Watermark Coal Project

Residual Matters following
Response to Submissions
OAS&FS

10 February 2014

**Residual Issues following
Response to Submissions
OAS&FS**

Criteria was used as a guide. (Refer to Figure 12 in EIS Appendix Y)

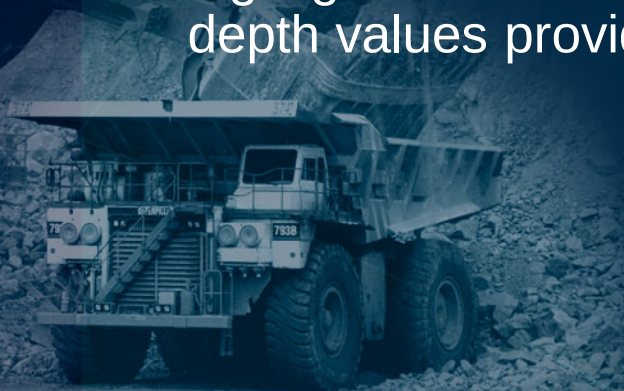
- The Elliot and Reynolds (2007) method of assessing material characterisation for reuse as topdressing in rehabilitation is used only as a guide. This is an industry accepted document.
- The topsoil balance is calculated to provide an overall indication of the volume of material to be salvaged, handled and available to achieve the required depths for rehabilitation. Variability in soil and practicalities of stripping soil need to be considered when discussing these soil volumes
- The topsoil stripping depths of four soil types (1, 4a, 6b and 7) were challenged by OAS&FS based on pH and EC

- The Elliot & Reynolds 2007 is considered a guide. Furthermore the 'R' box within the guide allows for 'Restricted' use, unless:

- a. Soil is ameliorated in some approximate way; or
- b. Soil is mixed with other more suitable materials;

Figure 4.1. Location of Revegetation and Rehabilitation Areas within the Onsite Offset Areas

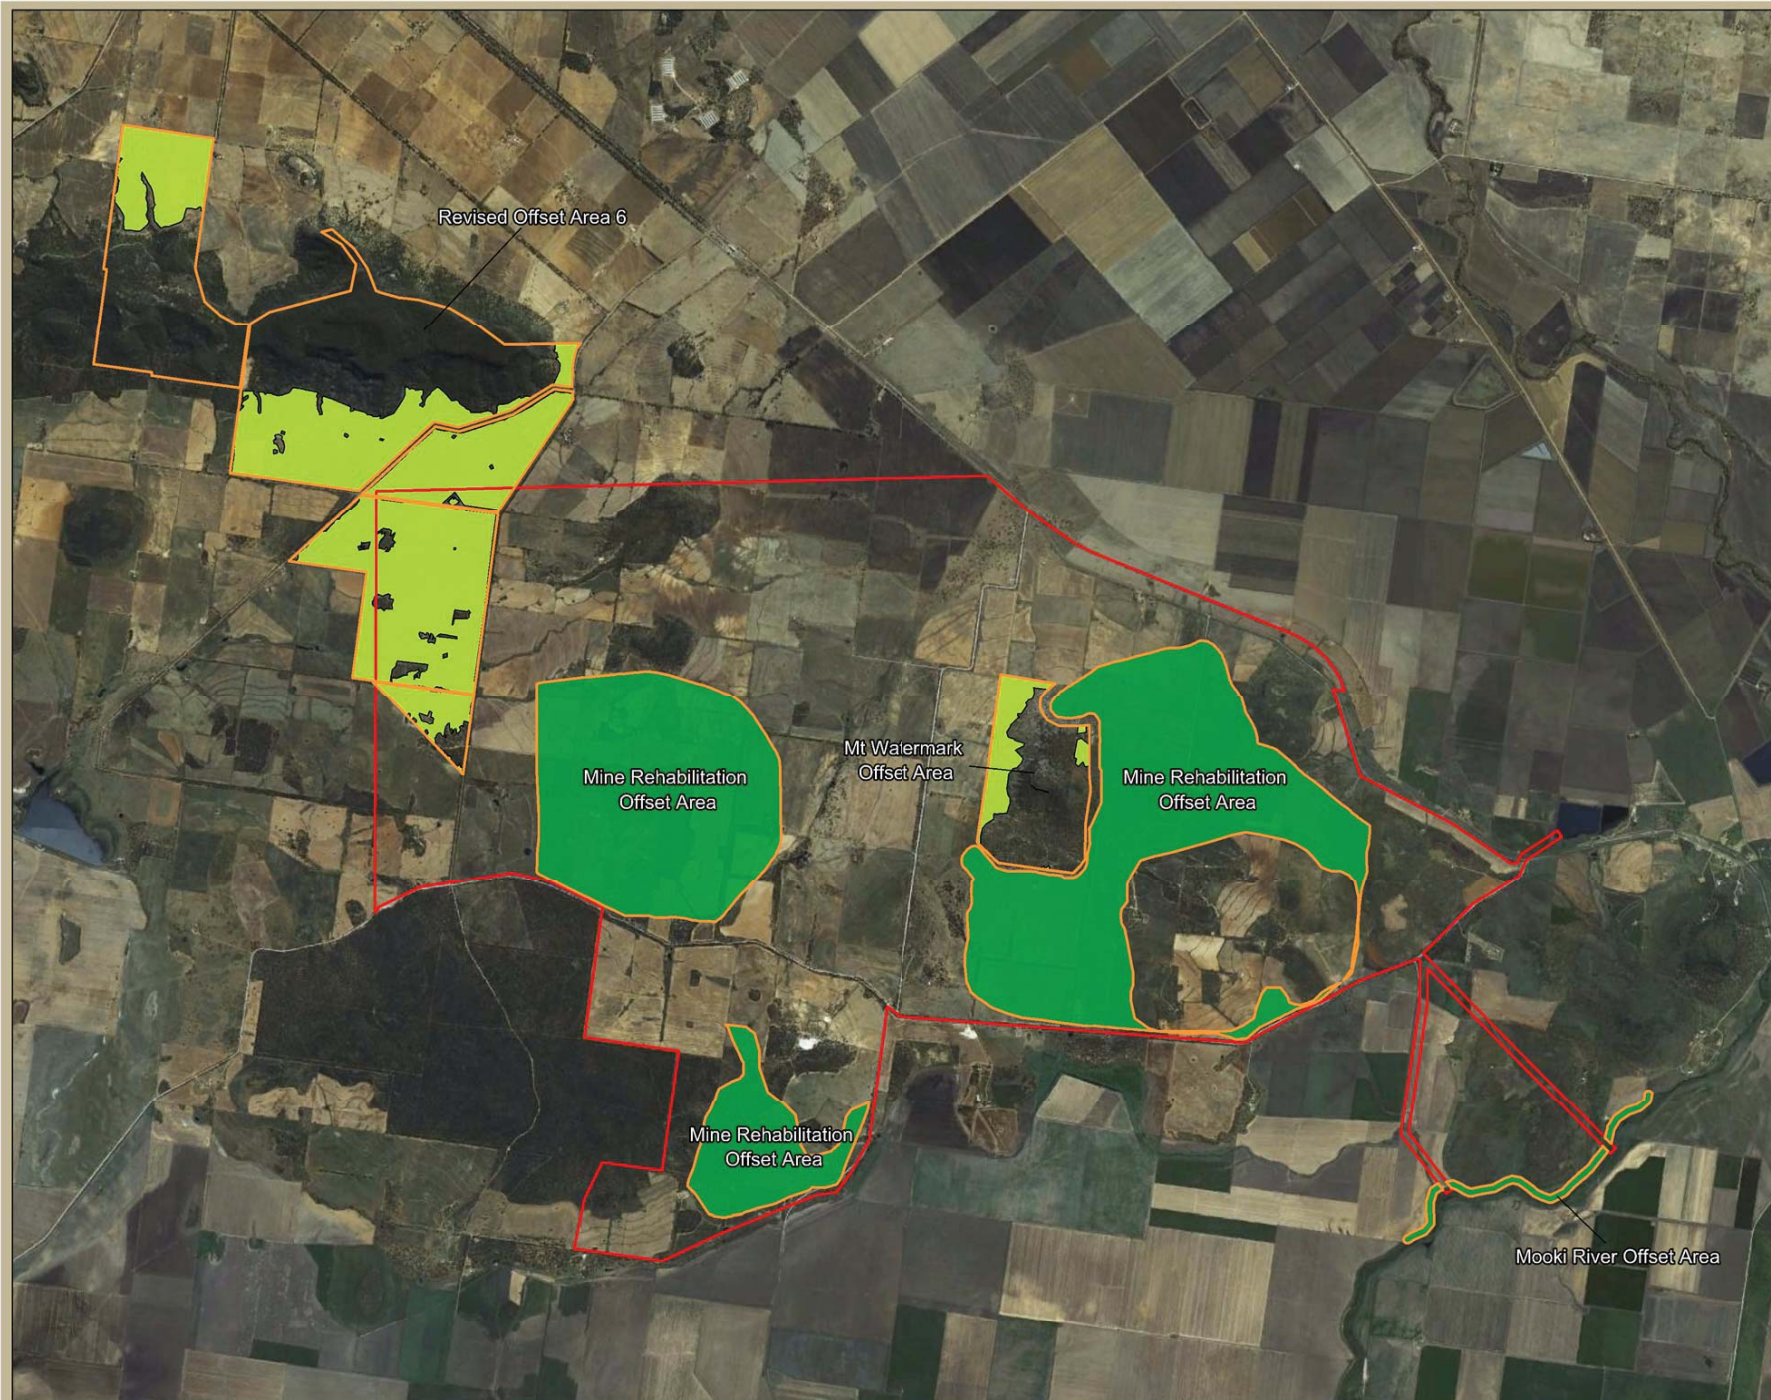
As outlined in **Section 1.2**, DoE raised concerns regarding the revegetation of Box Gum Woodland and Grey Box Woodland on "*improved pasture*" within Offset Area 6. To clarify, the areas to be revegetated are not predominantly comprised of this type of vegetation. Rather, these areas are comprised of Low Diversity Native Grassland (967 ha) and Cropland / Exotic Pasture (139 ha).

The proposed woodland to be regrown from grassland in Offset Area 6 can be made to fit a form of the endangered ecological community, using the definitions provided in the EPBC Act identification guidelines. The guidelines for Grey Box Woodland include condition classes ranging from intact woodland to degraded woodland (with few non-grass understorey species) and derived grasslands (Threatened Species Scientific Committee, 2010). At a minimum the proposed offset would be able to satisfy Condition Threshold 4.

Table 3 summarises how the criteria for the Condition Threshold 4 for Grey Box Woodland could be met by Offset Area 6. Revegetation works will be targeted towards meeting the proposed future quality for this community. As described above, the likely success of revegetation will increase with appropriate management activities. It is anticipated that the quality of the vegetation will continue to improve beyond 30 year life of the Project.

Figure 1 – Proposed Watermark Gully Detention Basin Locations

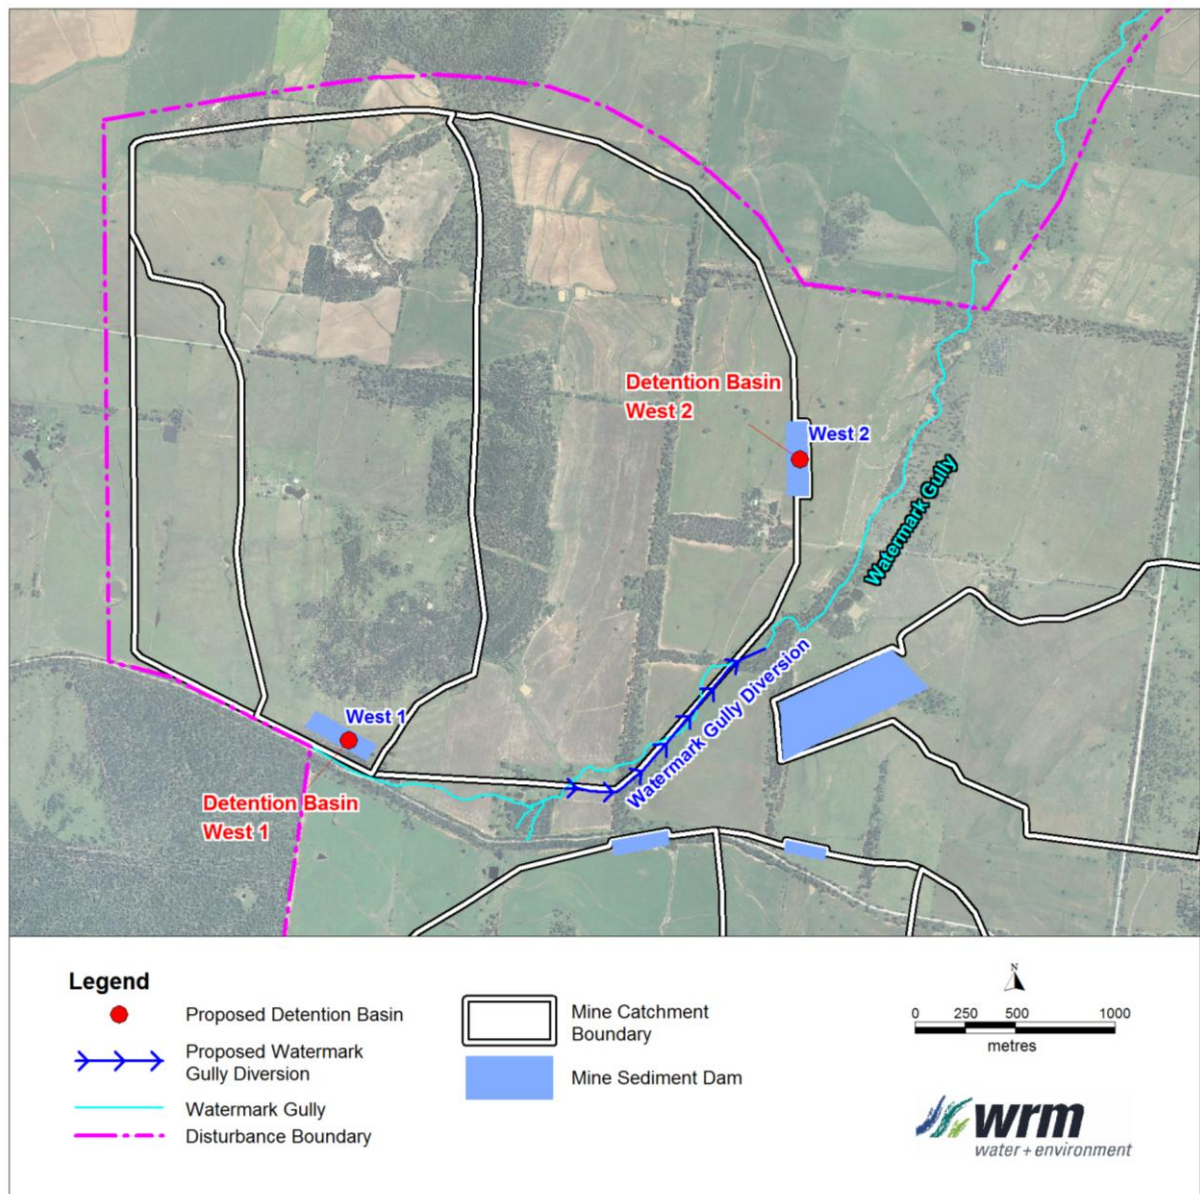
proposed sediment dams West 1 and West 2 (see Figure 1) and that the detention storages will remain as permanent features at the completion of mining. Key design parameters of the proposed detention basins are provided in Table 1.

The TUFLOW hydraulic model of Watermark Gully, described in Section 4.3.12 of the Response to Submissions, was used to assess the flood level and velocity impacts with proposed detention basins in place.
